**MONTGOMERY COUNTY HISTORIC PRESERVATION COMMISSION**  
**STAFF REPORT**

<b>Address:</b>	9 West Kirke Street, Chevy Chase	<b>Meeting Date:</b>	2/8/2023
<b>Resource:</b>	Non-Contributing Resource (Chevy Chase Village Historic District)	<b>Report Date:</b>	2/1/2023
		<b>Public Notice:</b>	1/25/2023
<b>Applicant:</b>	Josh Harrison and Jamillia Ferris (Phillip Long, Agent)	<b>Tax Credit:</b>	N/A
<b>Review:</b>	HAWP	<b>Staff:</b>	Michael Kyne

**PROPOSAL:** Hardscape alteration, fence installation, and driveway alteration

Fig. 2: Revised site plan.

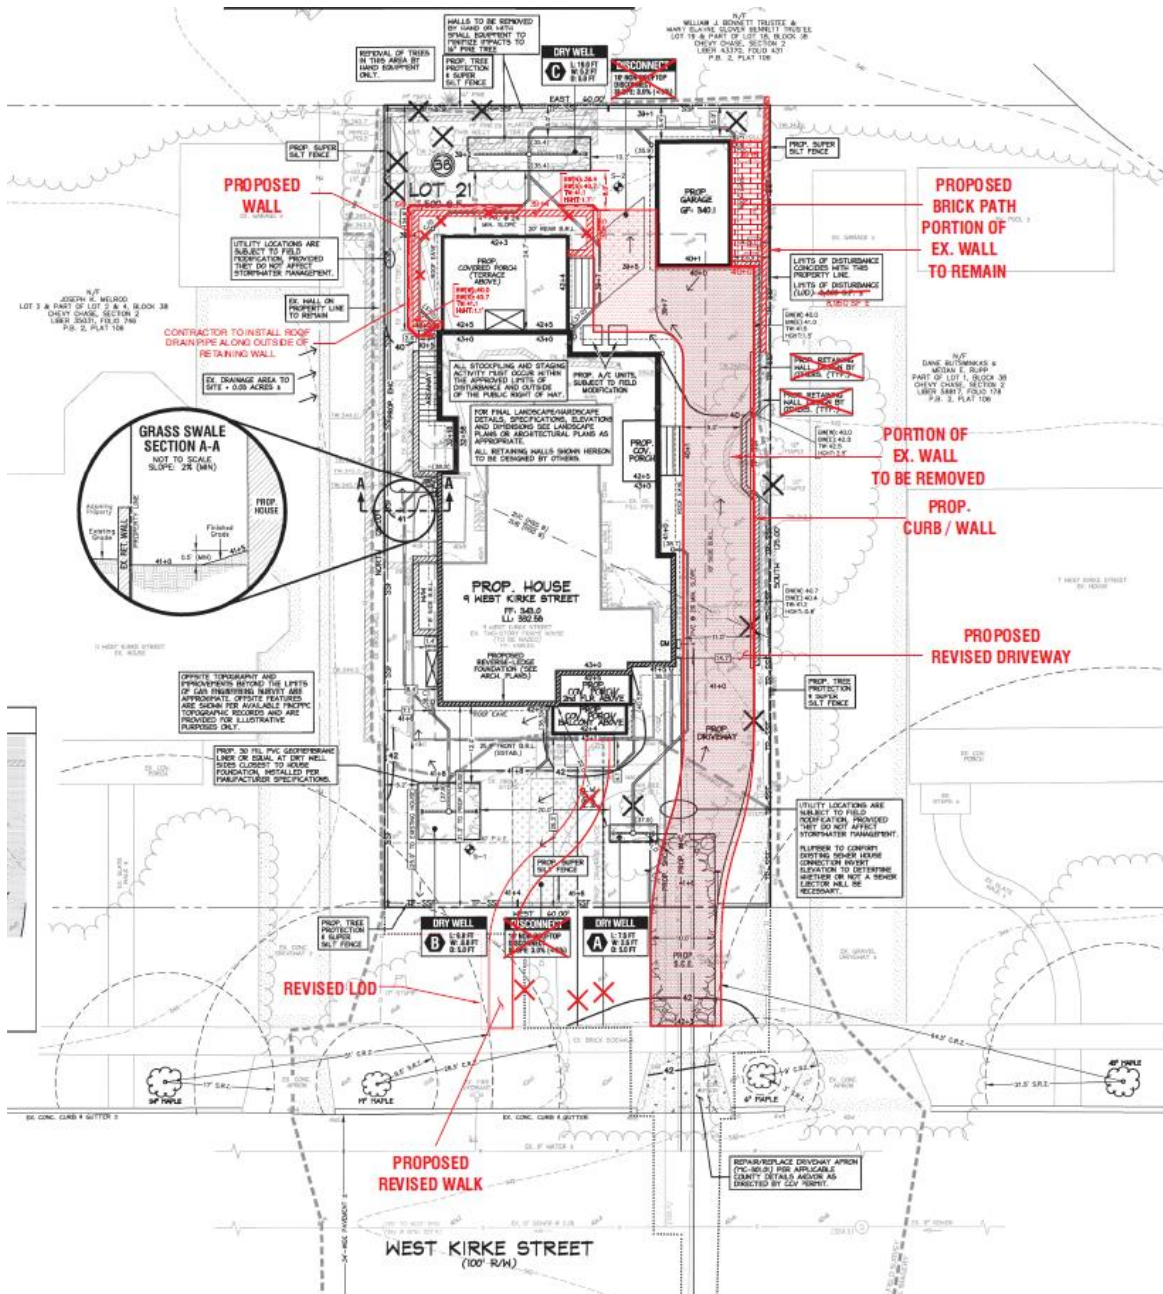
The current proposal calls for hardscape alteration, fence installation, and driveway alteration at the subject property. Specifically: a 3' high brick retaining wall is proposed at the rear/left side of the new house; the previously proposed driveway is to be expanded between the rear porch and garage; a new brick-paved walkway, which will serve as a trash enclosure area, is proposed at the right side of the garage; the previously proposed front walkway has been revised, going from straight to curved; and new fencing is proposed at the rear/left, rear, right side, and front of the property.

Staff notes that, except for a section of existing retaining wall at the rear/right side of the property, both the existing and previously proposed right-side retaining walls have been removed from the plan. The feature called out as “Prop. Curb/Wall” at the right side of the driveway on the revised site plan will be a minimal rolled curb.

Fig. 3: Proposed fence plan.

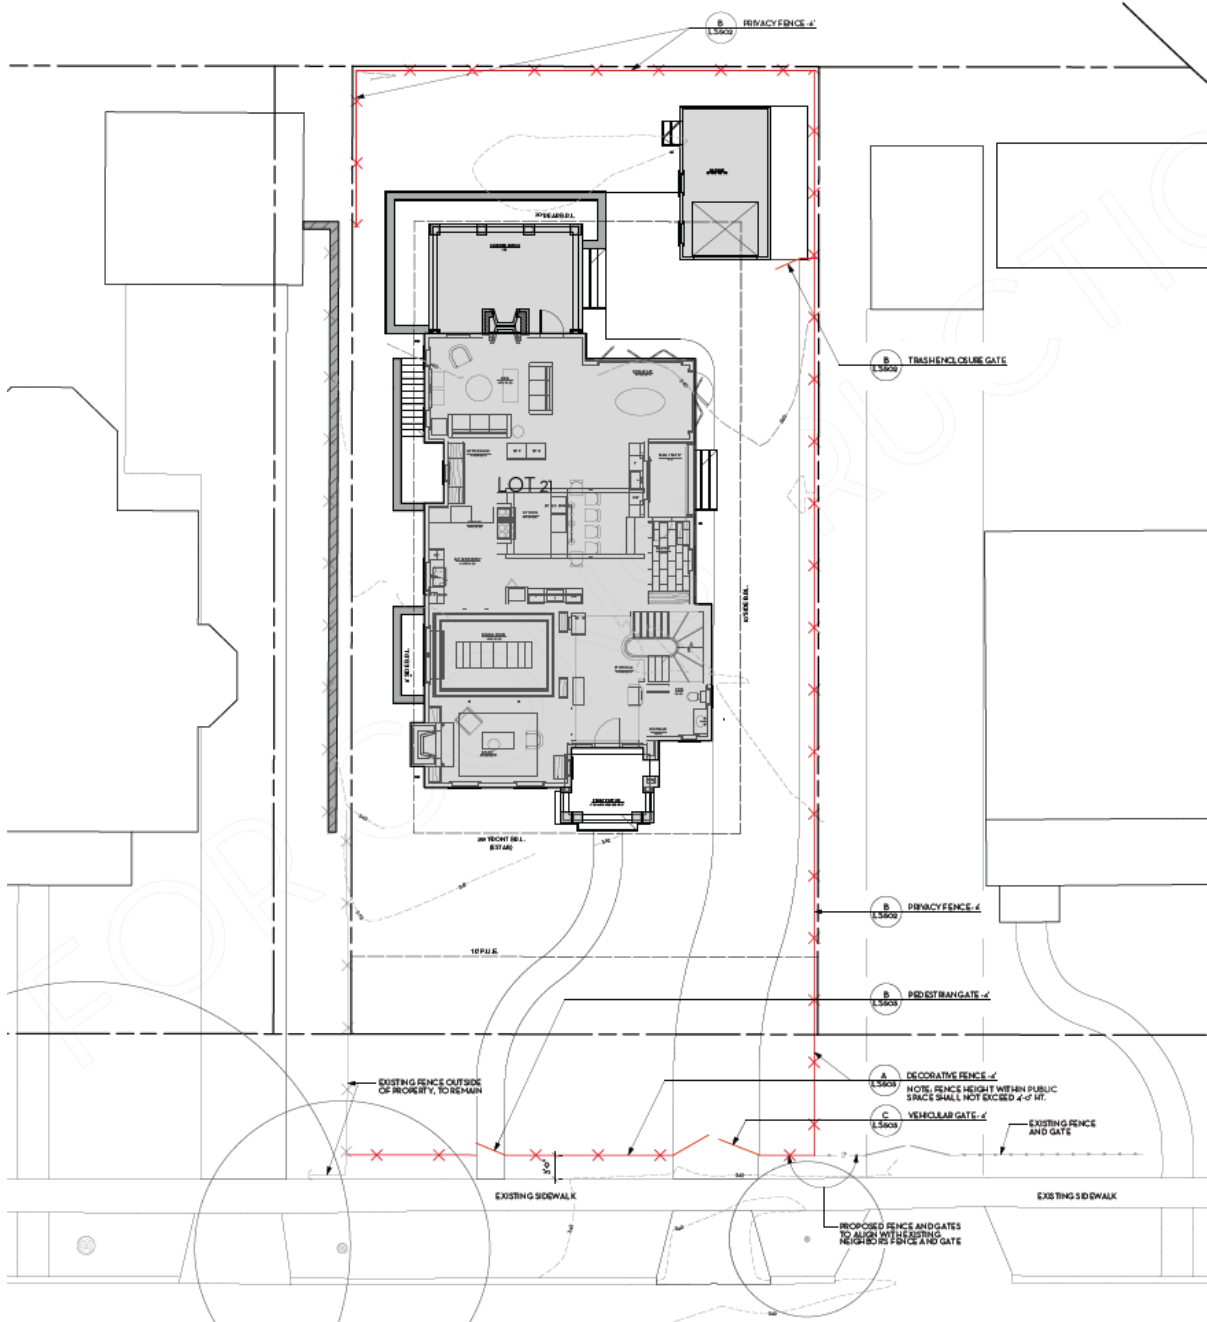
The proposed new fencing includes a 6' high board-on-board wooden privacy fence at the rear/left, rear, and right side of the property. On the right side, the proposed 6' fence will transition to a 4' high wooden picket fence near the front of the property. Additionally, a 4' section of board-on-board fencing with gate is proposed between the right-side fence and garage for a trash enclosure, and 4' high wooden picket fencing with a pedestrian and vehicular gate is proposed at the front of the property.

Staff is generally supportive of the applicants’ proposal, finding it compatible with the subject property and *Guidelines* for Non-Contributing/Out-of-Period Resources. However, in order to ensure compatibility with the surrounding streetscape and preserve the open park-like character of the district, staff finds that the proposed 6’ high privacy fencing at the right side of the property should not extend forward of the rear wall plane of the house. Any additional fencing in front of the rear wall plane should be no higher 4’ and open picket style.

- 1. The proposed fencing along the right side of the property will transition from 6' privacy fencing to 4' picket fencing at the approximate rear of the house, with final review and approval delegated to staff.**
